RE: RESPONSE TO INFORMATION REQUEST REFERENCED AS MCUC 2026_5943/I

We refer to the Information Request issued by Douglas Shire Council dated 20 May 2026 (Doc ID: 1366718) under Section 12 of the Development Assessment Rules V3 in respect of the above-referenced development application. We thank Council Officers for their detailed review and constructive advice notes.

PROJECT
LOT 3 DAGMAR CLOSE - LOWER DAINTREE
TITLE
BULK EARTHWORKS

Lot 3 Dagmar Close, Lower Daintree Geotechnical Assessment

Earthworks and Swept Path Plan

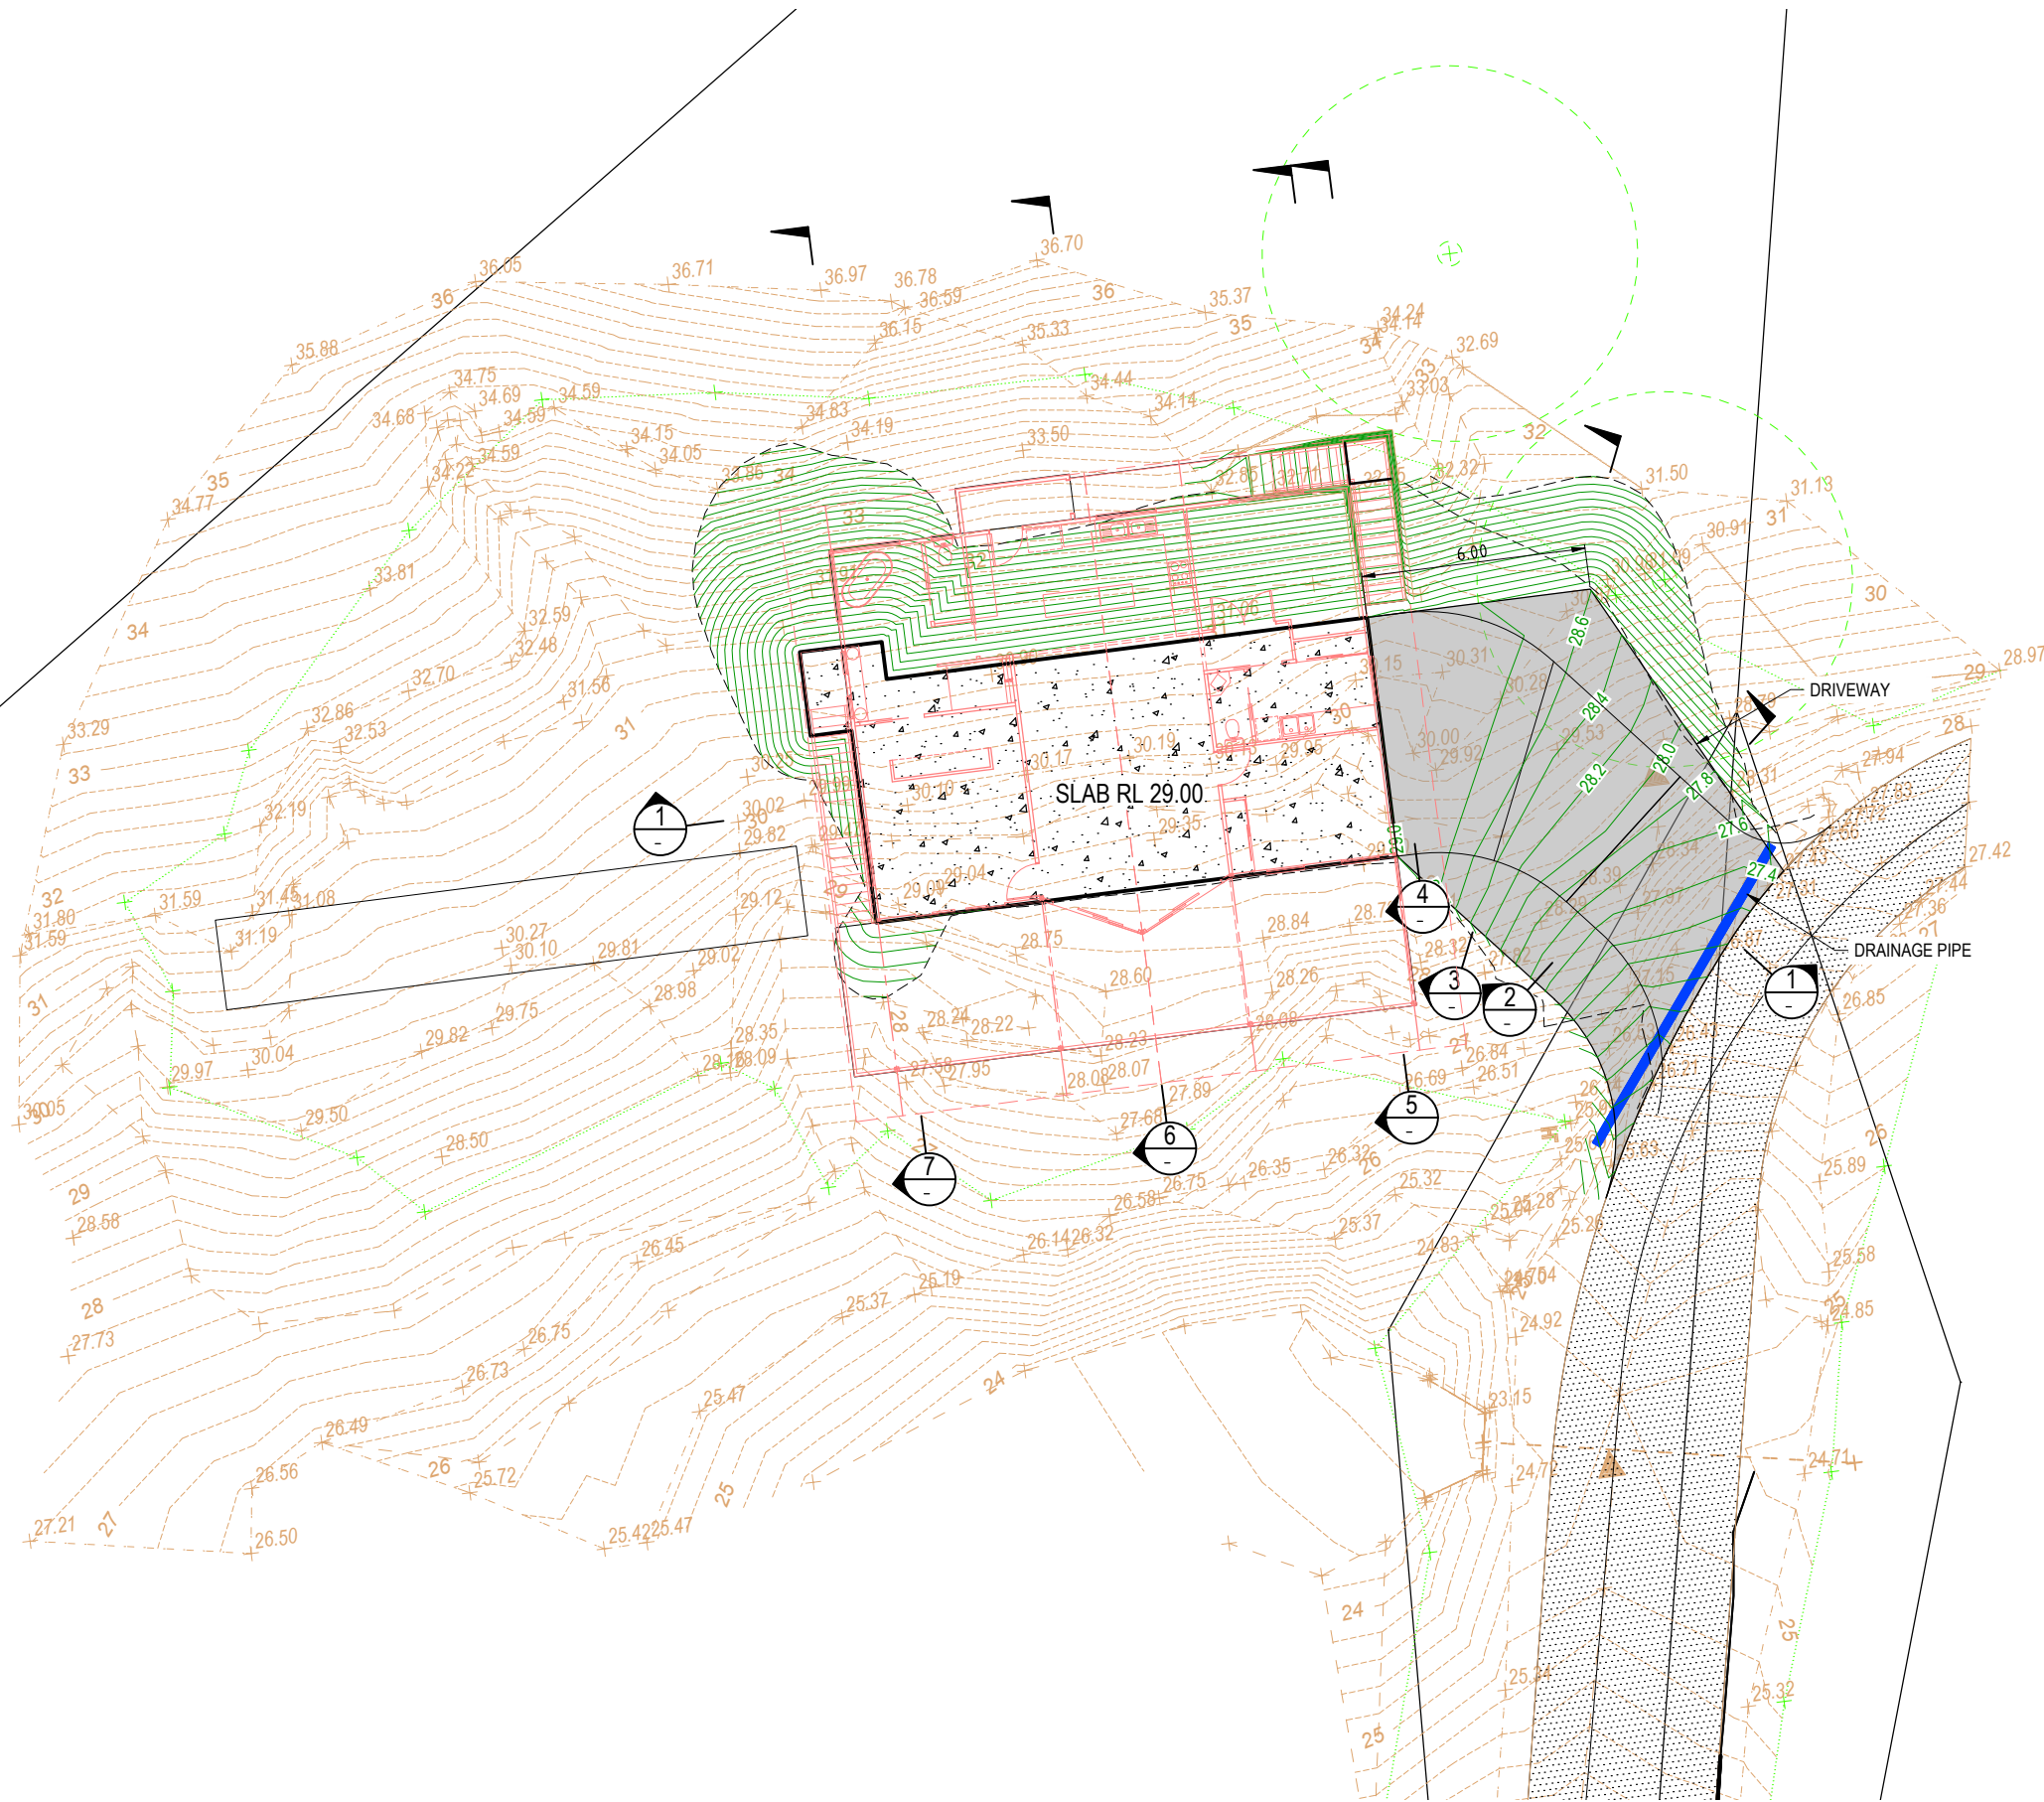
Item 1 – Earthworks Design

An Earthworks Plan prepared by All Civil Design Consultancy is enclosed as **Attachment 1**.

The plan identifies the proposed extent of earthworks and includes:

- the areas affected by earthworks;
- the proposed batter configuration;
- relevant cross-sections and the relationship of the works to the existing benched areas;
- the location and extent of the proposed development footprint; and
- the removal of one tree within the earthworks area.

The proposed earthworks are limited and localised around the development footprint. They do not involve extensive reshaping of the land or earthworks of a scale that would materially alter the existing landform or drainage characteristics of the site.

The earthworks design principally relies upon appropriately graded and stabilised batters. The plan identifies the location and extent of any proposed retaining structures where required. Detailed engineering specifications, including batter stabilisation, drainage treatment and erosion and sediment controls, can appropriately be finalised as part of the subsequent detailed design and conditioned by Council.

The Earthworks Plans included under **Attachment 1** identify the existing tree locations and canopy extent based on survey information. The plans demonstrate that only one tree is required to be removed to facilitate the development.

TITLE
VEHICLE SWEEP PATH

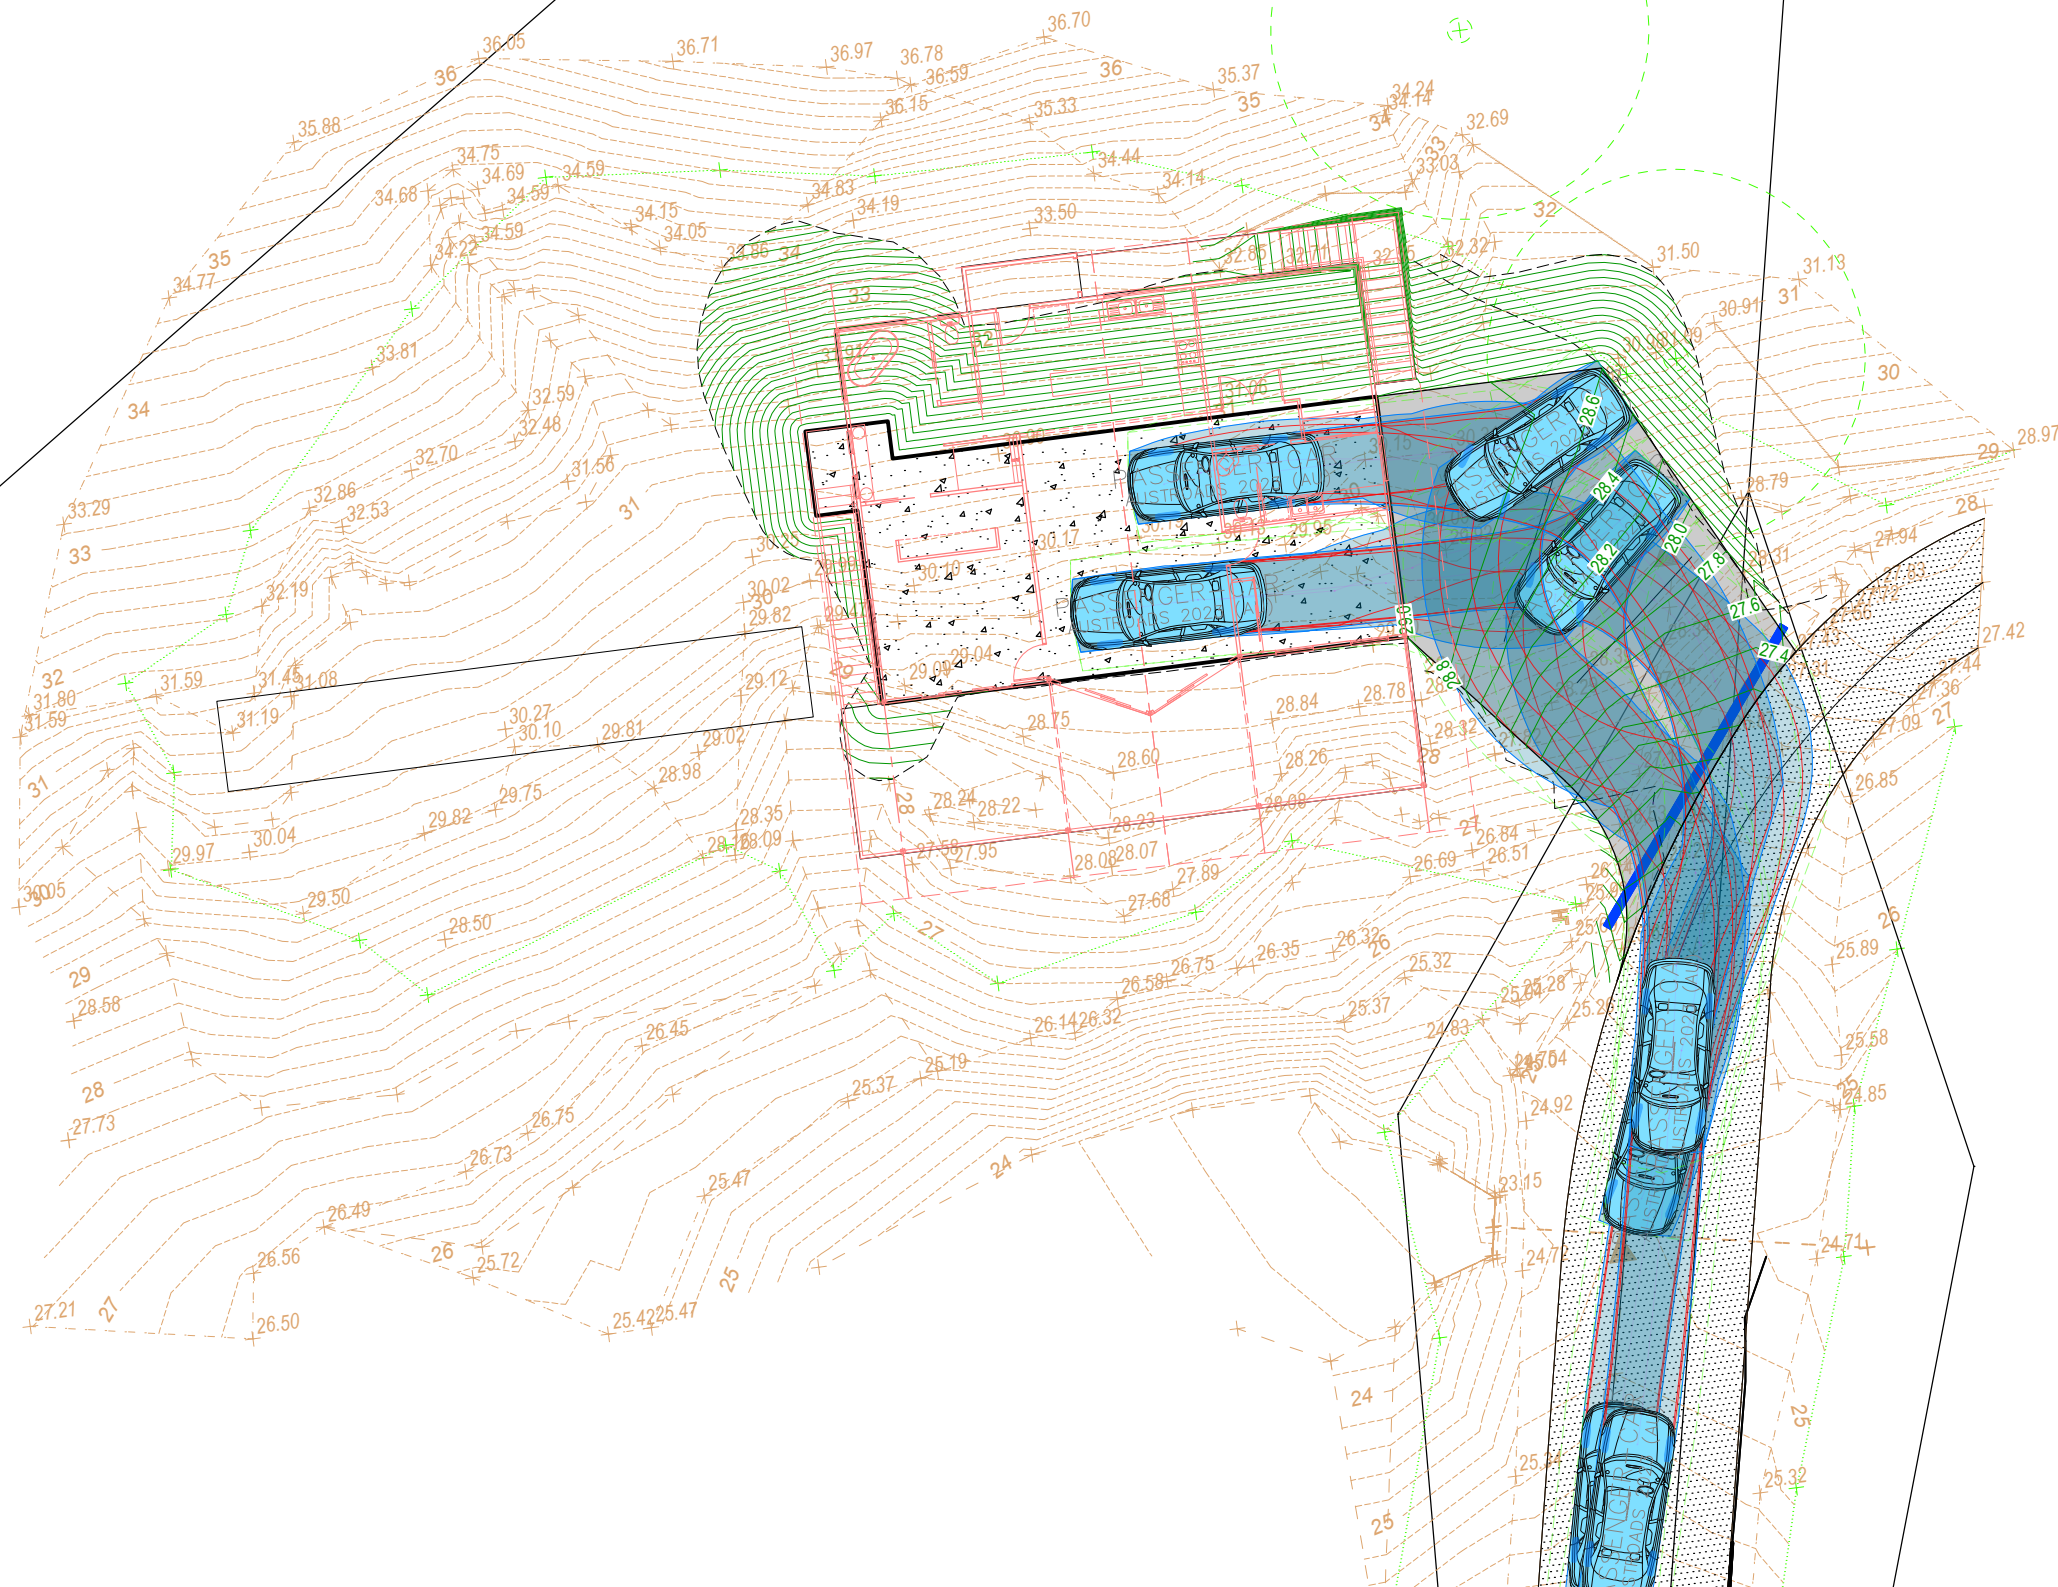
Item 4 – Vehicle Turn Around

The Engineer Plans included under **Attachment 1** illustrates vehicle swept paths facilitating vehicle entry and exit in forward gear.
